RESEARCH REACTOR CENTER

Reference: Docket 50-186
University of Missouri-Columbia Research Reactor
Amended Facility License R-103

SUBJECT: Written communication as specified by 10 CFR 50.4(b)(1) regarding the response to the
“University of Missouri at Columbia – Request for Additional Information Re: License
Renewal, National Historic Preservation Act (TAC No. MD3034),” dated April 30, 2010

ATTACHMENT 10

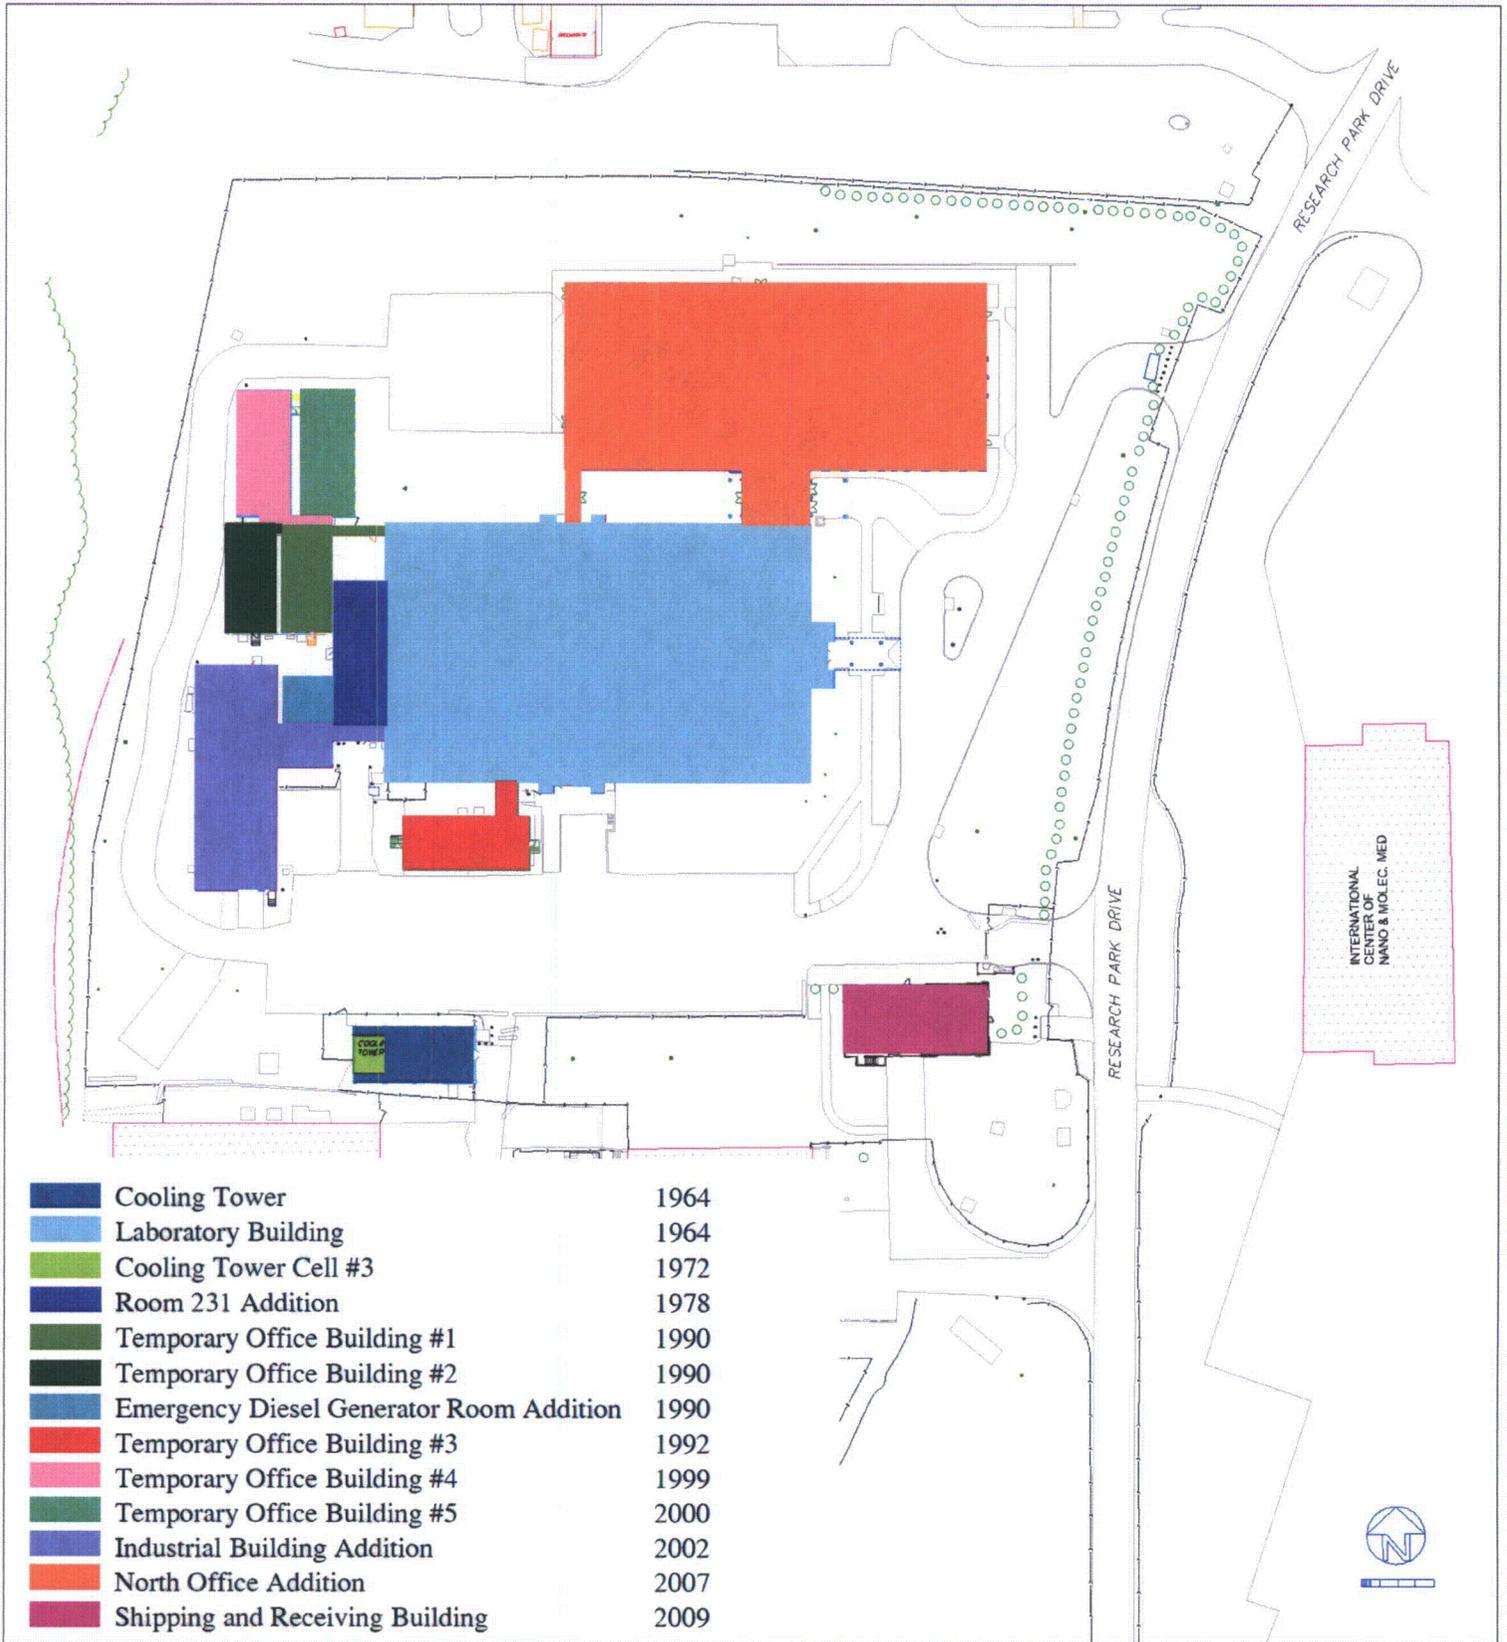
6. *Please provide a brief history of the building(s), including construction dates and building uses.*

The MURR was originally constructed in 1963-65 with two structures: the main building, which houses the Laboratory and Reactor Containment Buildings, and the associated Cooling Tower. The main building is now colloquially known as the "Laboratory Building." Several additions and an additional building have been added over the years.

For reference, please see the attached site map (Attachment 10) of these locations.
